HARDY ASSOCIATES (1978) LTD.

File No. K4946

June 22, 1981

RE: Cassiar Asbestos Mine,
Waste Dump and Tailings
Pile Stability

PHOTO 1 - Clinton Creek downstream of closures, note undercutting of both banks.

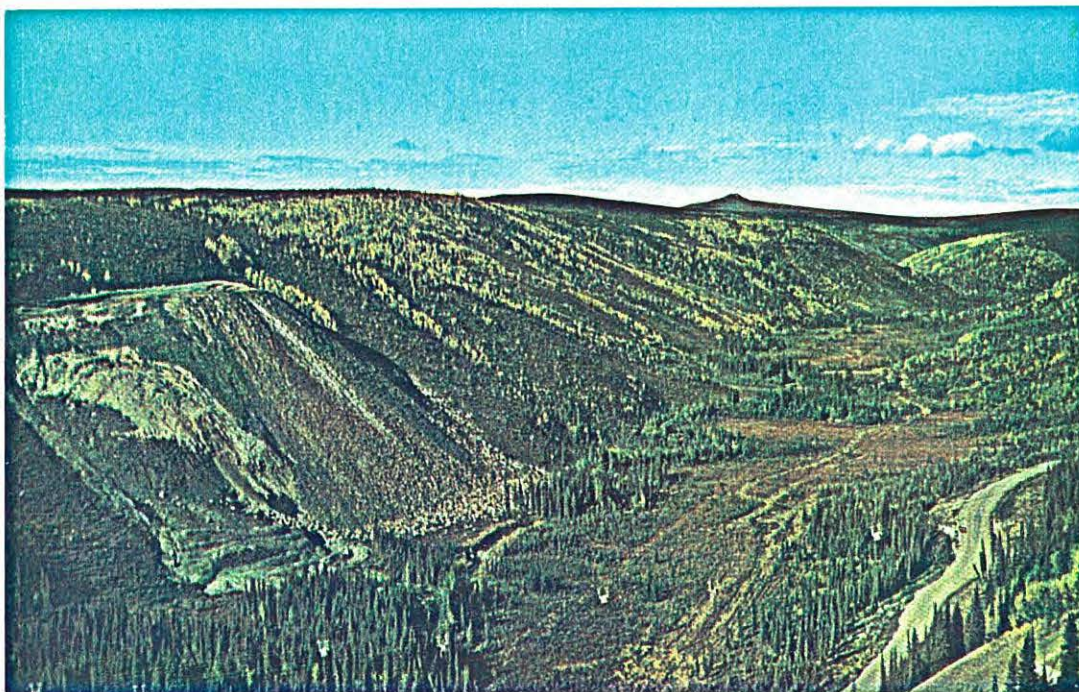
Despite a relatively low spring runoff, the banks of the creek channel show fresh sloughing and erosion scars (Photo 1).

PHOTO 2 - Post Card showing an initial dump stage, note the instability of left dump portion.

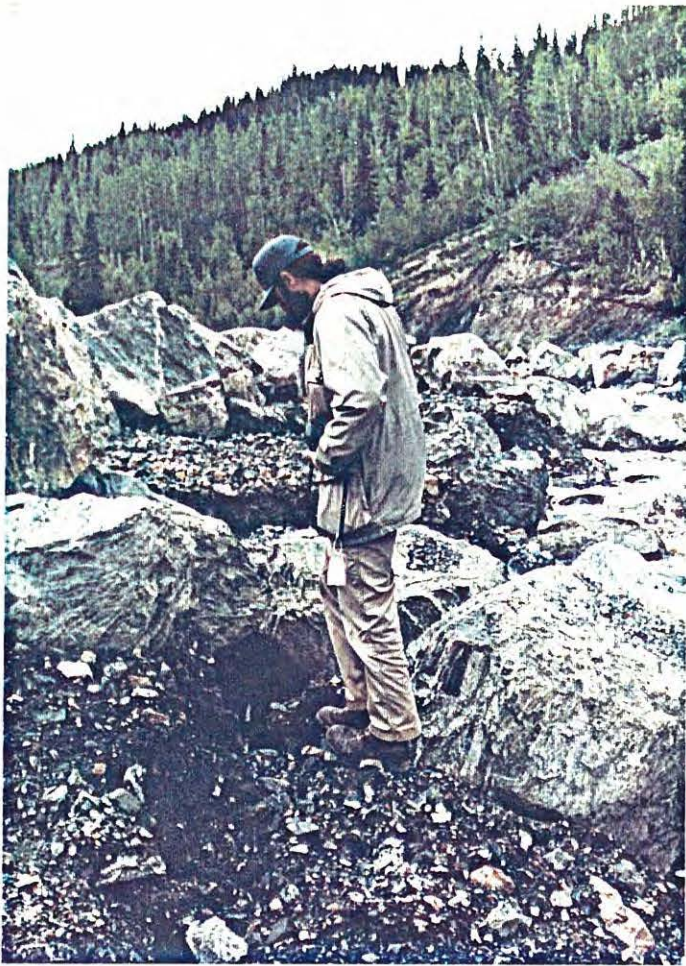
1.3 Initial dump failure. An old post card (Photo 2) obtained during the site visit and showing the initial stage

of the dumping operation, illustrates several aspects which are of interest when evaluating the dump failure. These, in my view, are:

- angle of repose of the waste material is greater than the shearing resistance of foundation materials,
- the dump failed due to the failure of its foundation, both on the slope and in the valley bottom,
- the movement resulted in a net decrease of shearing resistance (along the slip planes) from its original peak to residual strength value,
- the stabilization of the dump, if left to natural processes, will likely take a very long time while the factor of safety against sloughing would be unlikely to significantly exceed the value of unity,
- the sloughing experienced during the initial stages of the dumping operation provided an early warning of possible problems resulting from uncontrolled dumping of waste material into this area.
